Access Compliance Report

Public Rights-of-Way

Intersection ID: 15229	Main Street: CHARLOTTE_DR	Cross Street: IDEAL_WY	Location: W
ADA ID: 75876E2A8B59	Ramp Type: Perp	Initial Pass/Fail: Fail	Overall Compliance: No
Severity Score: 13.75			
Codes/Mitigation Info/Possible Solution		Field Measurements/Component Compliance

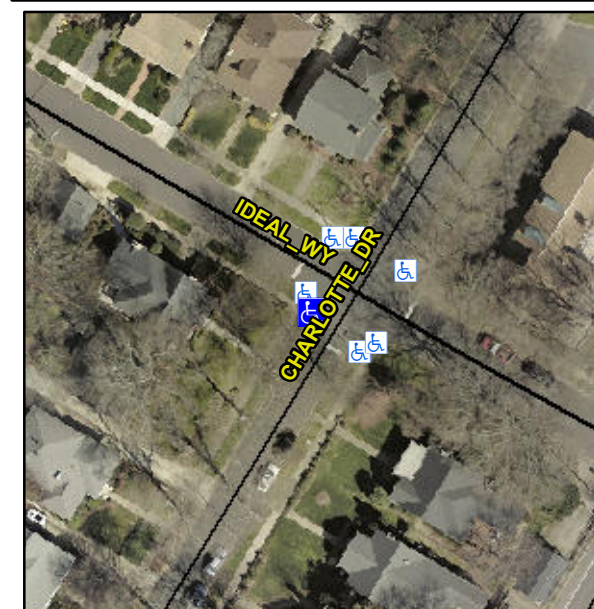
Not Found, R304.2.2, R304.5.3

Compliance	Description	Data	Compliance	Description	Data
N/A	Ramp Length (in)	77.0	No	Ramp Slope (%)	11.6
Yes	Ramp Width (in)	48.0	No	Ramp XSlope (%)	2.3
N/A	Flare Type LT	N/A	N/A	Flare Type RT	N/A
N/A	Flare Slope LT (%)	N/A	N/A	Flare Slope RT (%)	N/A
N/A	Flare Traversable LT?	N/A	N/A	Flare Traversable RT?	N/A
N/A	Landing Length (in)	N/A	N/A	DWS Provided?	N/A
N/A	Landing Width (in)	N/A	N/A	DWS Contrast?	N/A
N/A	Landing Slope (%)	N/A	N/A	DWS Length (in)	N/A
N/A	Landing X Slope (%)	N/A	N/A	DWS Full Width?	N/A
N/A	Landing Curb? (Y/N)	N/A	N/A	DWS Offset (in)	N/A
N/A	Shared Landing?	N/A			
N/A	Gutter Ponding?	N/A	N/A	Gutter Slope (%)	N/A
N/A	Gutter Lip Ht (in)	N/A	N/A	Gutter X Slope (%)	N/A
N/A	Painted X Walk1?	No	N/A	Painted X Walk2?	N/A
	X Walk 1 Direction	To SE		X Walk 2 Direction	N/A
N/A	X Walk 1 Width (in)	N/A	N/A	X Walk 2 Width (in)	N/A
	X Walk 1 Slope (%)	3.1		X Walk 2 Slope (%)	N/A
	X Walk 1 X Slope (%)	3.5		X Walk 2 X Slope (%)	N/A

Remove & Replace Entire Ramp.
